SAFETY ALERT

Product Safety Bulletin No. 3

Service loop – Static charge

Serial numbers: SN13 – SN38

Service Loop Mounting Brackets

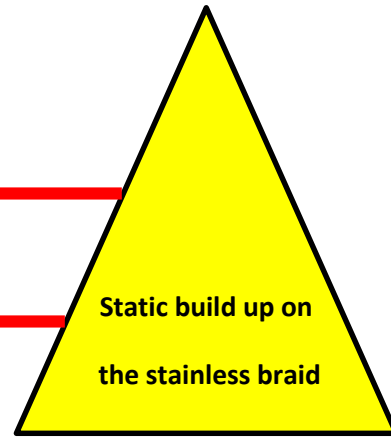
It has been determined that a static charge build up can occur on the stainless over braid covering the power cable leads as a result of the braid being ungrounded. This build up could result in a perceptible shock to the hoist chain or cable if it were to come in contact intermittently with the braid. The magnitude of charge buildup is unknown at this time, but, due to the short length of the braid, it should be well below a harmful level.

An external grounding solution will be sufficient to dissipate static charge to ground safely. GDS is providing a grounding kit that should be installed according with the following instructions.

Remove the lifting eye from either side of the flange. If the lifting eye is not present, use bolts included in the repair kit.

1. Scrape the paint off of the flange to create a clean mating surface with the earth tag.

2. Place the nickel plated earth tag on the surface of the flange. Screw the lifting eye or bolt back on the flange and tighten securely.

3. The exposed copper on each of the insulated leads from the earth tag should be placed on the armor braid, and then the spring clamp should be applied to secure the copper to the braid.
4. Apply the spring clamp two laps around the braid and grounding lead. Bend the conductor from the lead backwards over the spring clamp (as shown in figure below). Complete the application of the spring clamp.

5. Use the Scotch 50 Corrosion Protection Tape provided in the tool kit to cover the assembly. Use three layers with 50% overlap applied under tension and cover the assembly at least two inches on each side of the clamp.
